| | Project: Belsize Park Firestation | | Drawn By: TS |
| | Drawing Title: Proposed Ground Floor Plan | | Scale: 1:100 @ A1 |
| | Drawing Number: BFS THA PR PA 100 P3 | | Drawing Status: Planning |

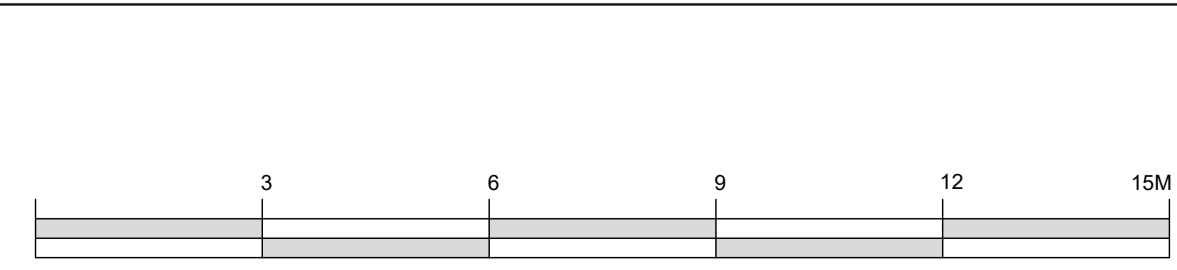
List of changes from consented scheme:

- Unit 1 - As per consented scheme. please refer to NMA for unit 1.
- Unit 5 - Amendments to internal layout. Side extension lowered by 200mm. Mezzanine storage area included to bedrooms. New dropped external access to side extension.
- Unit 6 - Amendments to internal layout. Side extension lowered by 200mm. New dropped external access to side extension.
- Unit 12 - Amendments to internal layout.
- Unit 13 - Amendments to internal layout.
- Unit 14 - Amendments to internal layout.
- Boiler room made smaller to prevent knocking through existing wall.
